Application for Licence Amendment

Licence Number	L8435/2010/3
Licence Holder	GSM Mining Company Pty Ltd
ACN	165 235 030
File Number	2011/000299-3
Premises	Granny Smith Gold Mine LAVERTON WA 6440 Part of mining tenements: L38/329, L38/80, L38/106, L38/144, M38/18, M38/1280, M38/161, M38/162, M38/167, M38/191, M38/205, M38/287, M38/361, M38/380, M38/389, M38/397, M38/440, M38/525, M38/532, M38/690, M38/691, M38/692 and M38/725 As defined by the Premises maps attached to the Revised Licence
Date of Report	17 January 2025
Proposed Decision	Intent to grant revised licence

PROJECT
GRANNY SMITH MINE
TAILINGS STORAGE FACILITY CELL 4 DESIGN
STAGE 4A
TITLE
GENERAL ARRANGEMENT

Figure 4: Standing water levels 2021-2024

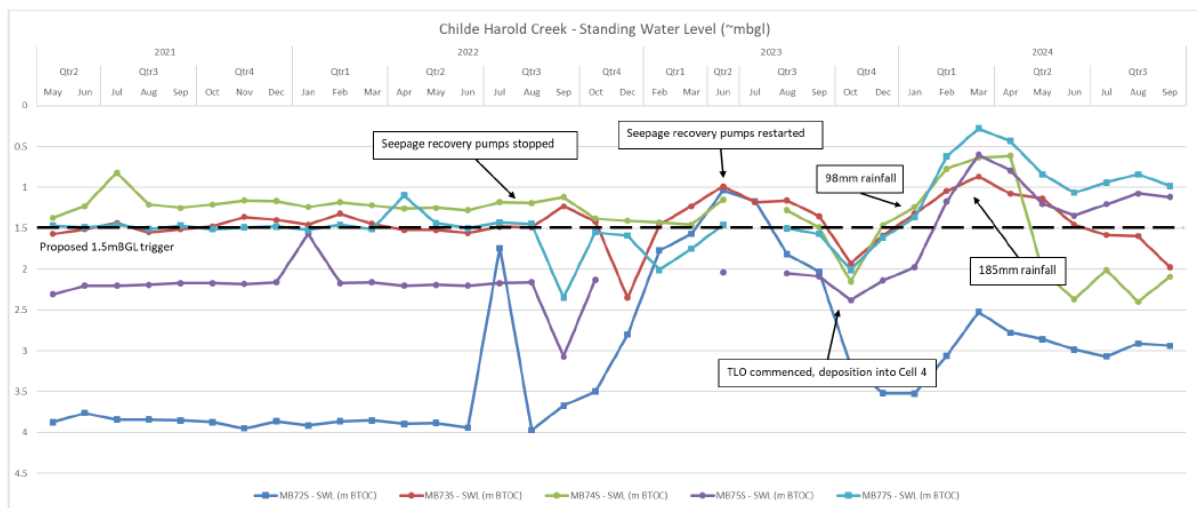
Internal advice provided by DWER’s Principal Hydrogeologist concluded that water levels in many of the shallow bores are at least periodically less than 3 meters below ground level and therefore exceed the 3 meter deep trigger value that is often set by the department to protect native vegetation from the effects of soil salinisation. Research indicates that soil salinisation could become significant when the water table depth is less than about 1.5 metres. As the standard trigger value cannot be used, they recommended a new trigger value of 1.5 m for the shallow monitoring bores would adequately prevent shallow soil salinisation taking place. Additionally it was recommended that water level elevation in the deep aquifer should not exceed the elevation of the water level measured in the shallow aquifer for more than a two month period, or else the risk of soil salination becomes more significant.

Following from the draft comments received by the Licence Holder and a meeting with the Department on 10 October 2024, the Licence Holder outlined historical seepage management issues have been occurring. This summarised that they were seeing groundwater mounding at the monitoring bores as per Figure 5.

Consultation method	Comments received	Department response
Application advertised on the department's website on 10/05/2024.	No comments received.	N/A
Department of Mines, Energy, Industry Regulation and Safety (DEMIRS) advised of proposal 09/05/2024.	No comments received.	N/A
Licence Holder was provided with draft amendment on 11/09/2024	Comments received on 18/10/2024. and further clarification received on 31/10/2024. Refer to Appendix 1.	Refer to Appendix 1
Licence Holder was provided with 2 nd draft amendment on	Comments received on 22/12/2024: SWL on bores:	DWER agrees that these changes to bores with the SWL limit are justified. Figure 4 illustrates that

<p>12/12/2024.</p>	<ul style="list-style-type: none"> • Supportive of >1.5 m SWL applied to MB72. • Request MB75s be excluded from the limit due to location outside immediate drawdown zone of existing seepage recovery infrastructure and highly impacted by rainfall. • Propose the limit be applied to MB74s instead due to good location west of the TSF for spatial spread, water levels influenced by seepage pump utilisation from recovery bore PB07. • Suggested limit be applied to MB78s located north for spatial distribution. Note there is no seepage pumping infrastructure at this site which may limit its responsiveness to seepage optimisation. <p>Administrative:</p> <ul style="list-style-type: none"> • Remove MB76 as it was never drilled due to falling within registered heritage site. • Remove annual SWL reading requirement for MB56 as quarterly readings is required and supersedes. • Remove water transfer pond as an emission to groundwater as it is more appropriate to call containment infrastructure. The pond is fully lined and poses no pathway to groundwater. <p>Replace/add figures for clarity.</p> <ul style="list-style-type: none"> • Replace figure 1 of prescribed premises • Add additional figure to include TSF Cell 4 monitoring locations 	<p>MB75 and MB74 is both impacted by the rainfall events, however MB75 has taken longer to adjust afterwards compared to MB74 which spikes and then decreases under the limit. Additionally adding the limit on the third bore MB78 will provide more monitoring north of the TSF.</p> <p>Changes made.</p>
